HISTORIC AND DESIGN REVIEW COMMISSION

HDRC CASE NO: 2017-502

ADDRESS: 1021 N PALMETTO

TYPE OF WORK: Construction of 2-story single family home

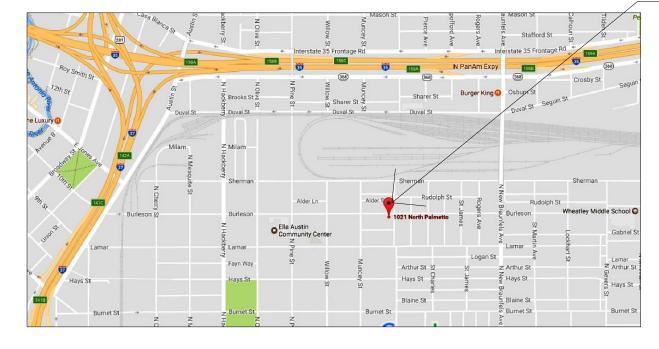
- 1. The porch was extended with wise and a beam with metal coping above added.
- 2. On the right side (facing Burleson) 2 windows on the 2nd floor were replace by french doors, a balcony and awnings were added,
- 3. On the powder room facing the front the window was replace with a bigger one for window consistency.
- 4. The roof overhangs were increase to 16"
- 5. The house was moved 7' towards Palmetto for setback consistency.

VIEW ALONG BURLESON

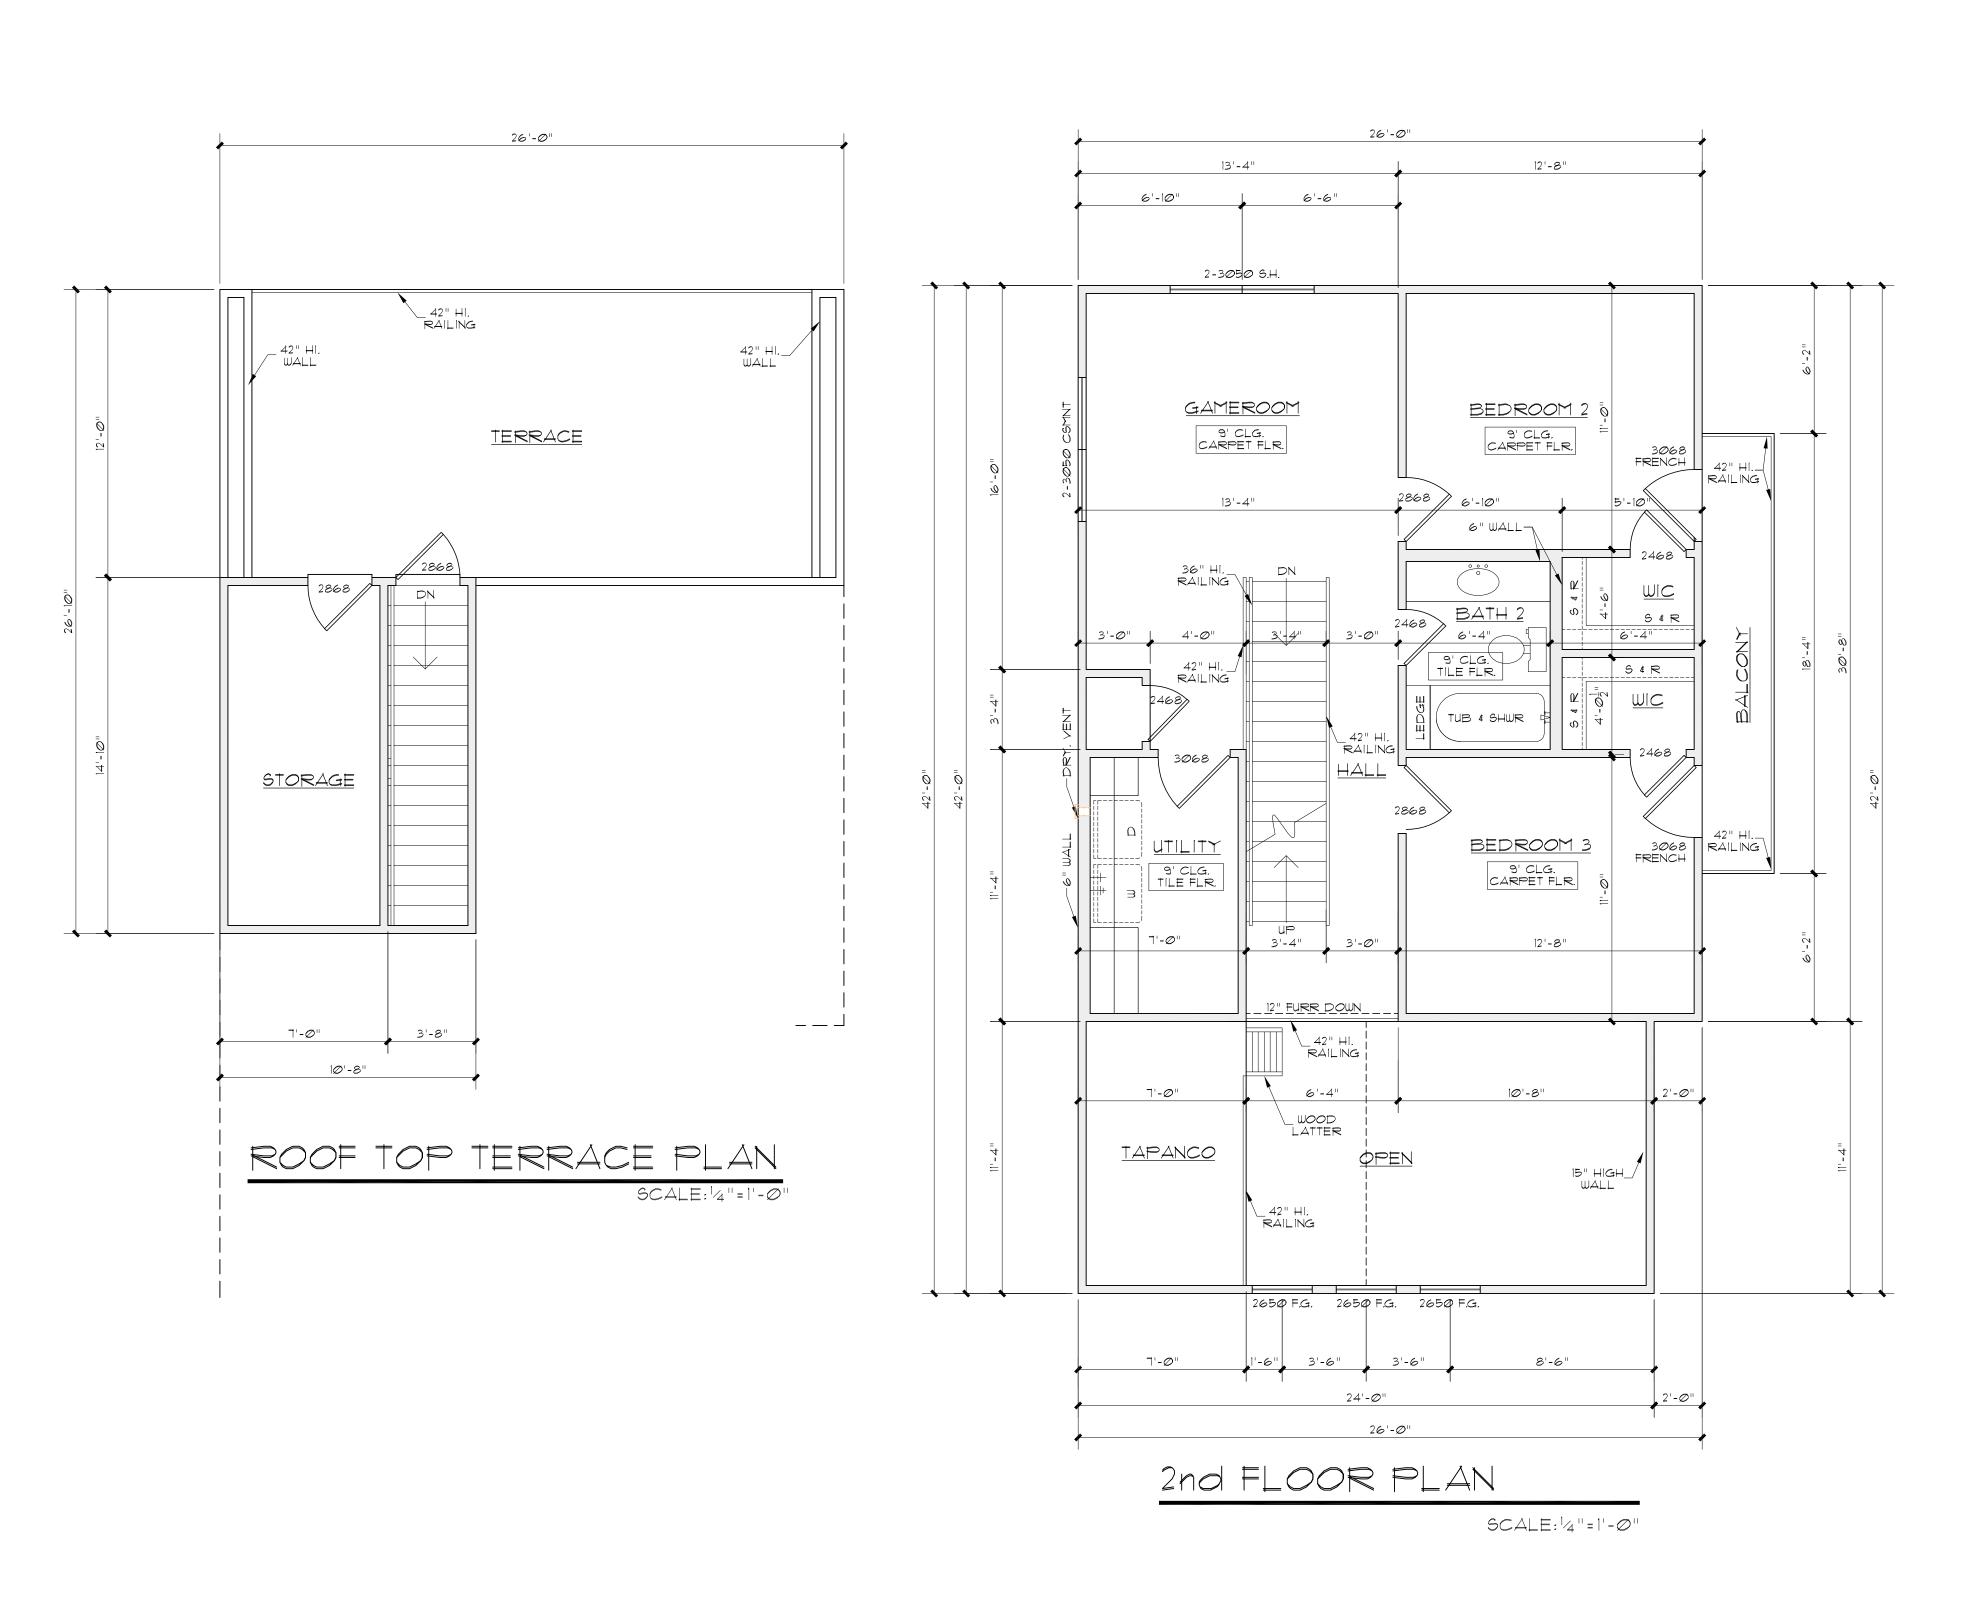
- g. SCALE & MASS Per the Guidelines for New Construction 2.A.i., a height and massing similar to historic structures in the vicinity of the proposed new construction should be used. The applicant has proposed a two story structure with a rooftop terrace. The highest point of the structure is indicated to be 28'-10 ½" without considering the foundation height. The height is generally consistent with the two-story structures nearby; however, the block is predominantly single-family homes with a maximum height of 20 feet at the roof ridgeline. Additionally, the massing of the structure, primarily the right façade that will face Burleson, is not similar to historic structures.

- iii. That the applicant explores overall massing similar to historic structures in the vicinity as noted in finding f.
- iv. That the applicant reconfigures the roof form to be more consistent with the roof forms of the district as noted in finding h.
